PROJECT APPROVALS

UTILITY COMPANY NARRATIVE

RE: Northeast Metro Technical High School
Project: 60-20-409

RE: Northeast Metrotech Regional High School
Gas Service Availability & Coordination
Bala Project No. 60-20-409

SERIES B3
 ROOTS® METER
 2M(G40)/3M(G65)/5M(G100)
 WITH CD* OR TD**
 IMPERIAL OR METRIC

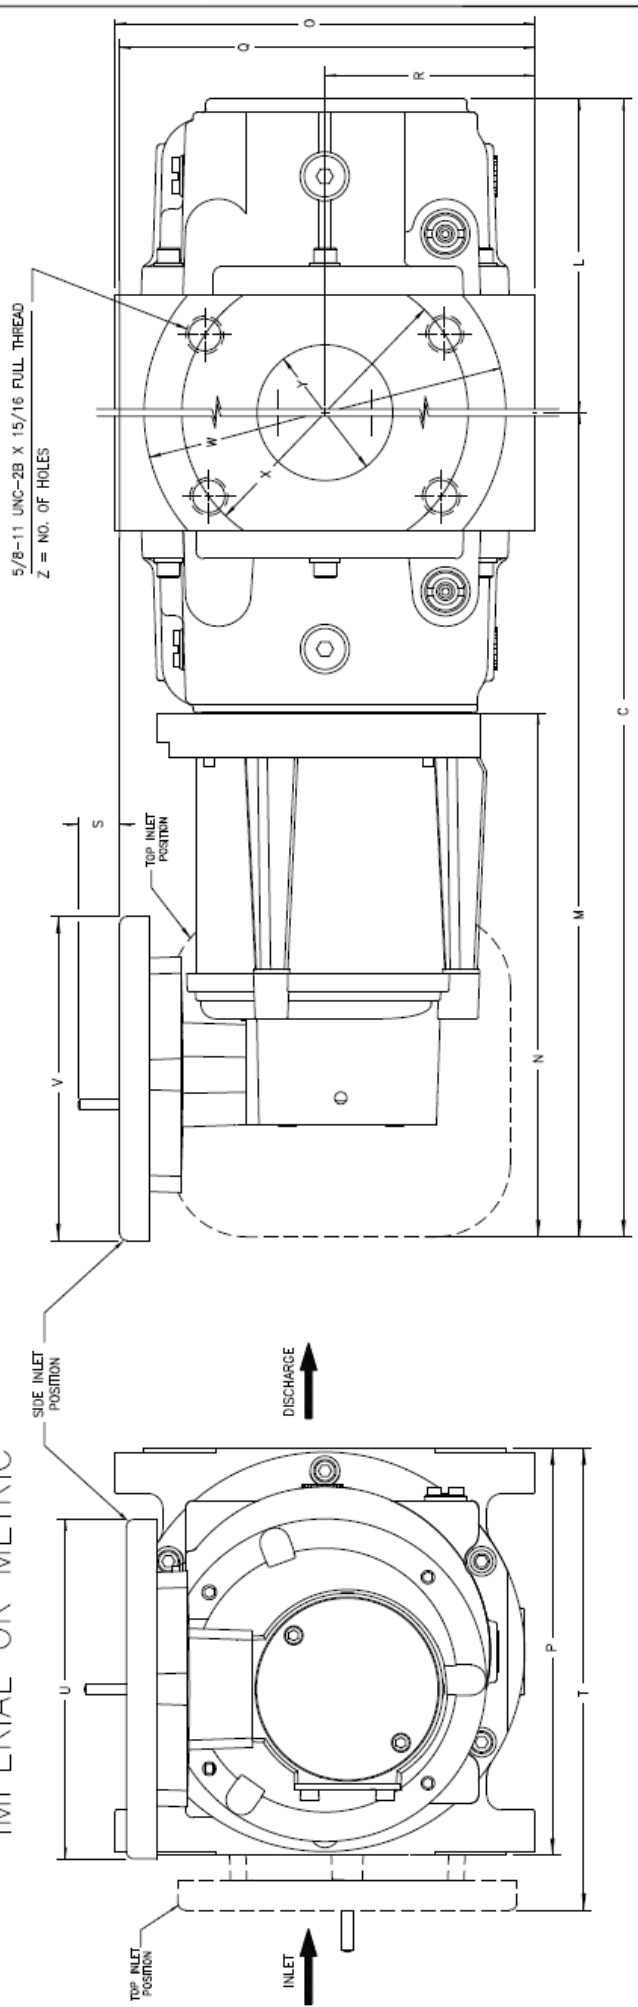
7. Confirm size of the meter assembly based on the total connected load and delivery pressure. Provide cut sheets of meter assembly for coordination.

The approximate size of the meter assembly is 21" x 8" x 7". The CAD drawing of the meter is included at the end of this letter. The model that will be used for this project is 3M (referenced in the dimensions table). Please note – the meter assembly must be set at least three (3) feet from any other feature including vents, windows, and electric lines.
